REGIONAL REVIEW FINDING

ARC REVIEW CODE: R712071

Submitting Local Government: City of Smyrna
Name of Proposal: Belmont Hills

Preliminary Report:	December 7, 2007	DEVELOPMENT OF REGIONAL IMPACT REVIEW REPORT	Project:	Belmont Hills #1563
Final Report Due:	January 6, 2008		Comments Due By:	December 21, 2007

DRAWN BY	
APPR	
CHECKED BY	
RH	
DATE	10-03-07
SCALE	1"=100'
X08 NO.	07059
CAD FILE	7059MASTER.dwg
PLOT DATE	12-7-07
SHEET	1

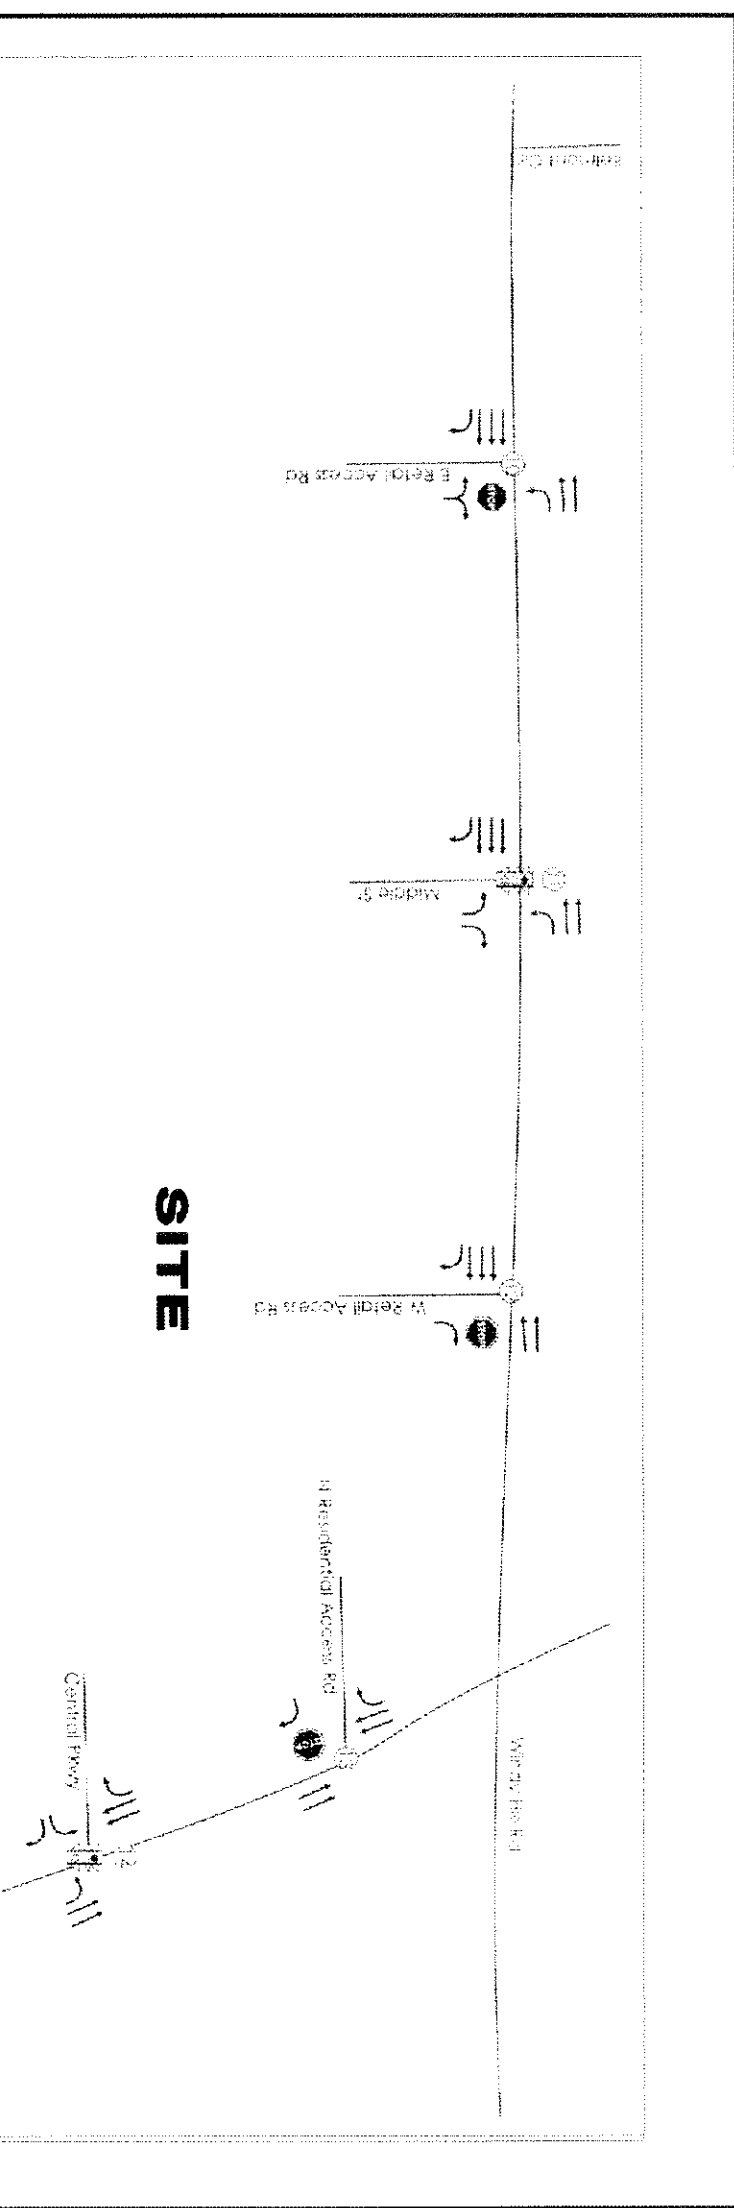
There is an LCI transportation project along Atlanta Road for a multi-use facility. It is important that the frontage along Atlanta Road is pedestrian oriented. Therefore, the site plan should be revised to include building orientation to Atlanta Road, minimal parking frontage along Atlanta Road, and pedestrian connections into the development so that all land uses within the development can be conveniently accessed.

The proposed development should allow for potential future access to adjacent property, particularly along the western of the edge of the property.

- In an effort to properly manage access onto Windy Hill Road (classified as an Urban Minor Arterial) and Atlanta Road (classified as an Urban Collector) ARC recommends eliminating driveway #3 (right-in/right-out on Windy Hill Road) and converting driveway #6 (currently full-access) to a restricted right-in/right-out driveway.
